PRESS RELEASE N. 5 of 06/11/2024

SUBJECT: **NEW TECHNICAL REGULATIONS EASYKART 2025:**

• New convoyer carburetor TRYTON MOD. HB-27

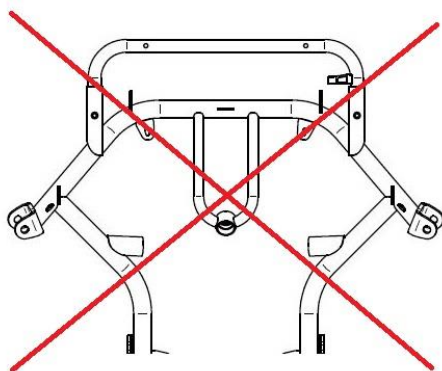
BMB mod. EKA equipped for Easykart 125 and mod. HAT for the category BMB CHALLENGE must be fitted with the new convoyer TRYTON mod. HB-27

1 – code 40.17334.00 - CONVOYER CARBURETOR TRYTON HB-24/27

The previous version of the convoyer code 40.9456.00 as in the technical regulations of 2024 trophy can not be utilized for the 2025 season.

- Prohibition of use old chassis Easykart mod. L28C-Y – R30C-Y

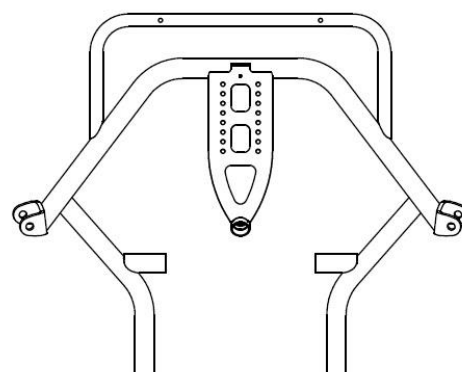
①

FRAMES NOT COMPLIANT WITH THE 2025 TECHNICAL REGULATION

②

FRAMES COMPLIANT WITH THE 2025 TECHNICAL REGULATION

Chassis mod. R30C-Y e L28C-Y with lower steering shaft support a “U” (1) can no longer be utilized for the ufficiale Easykart trophy 2025 and forward, chassis compliant with 2025 technical regulations are with lower steering shaft support mod. “IRON” (2).
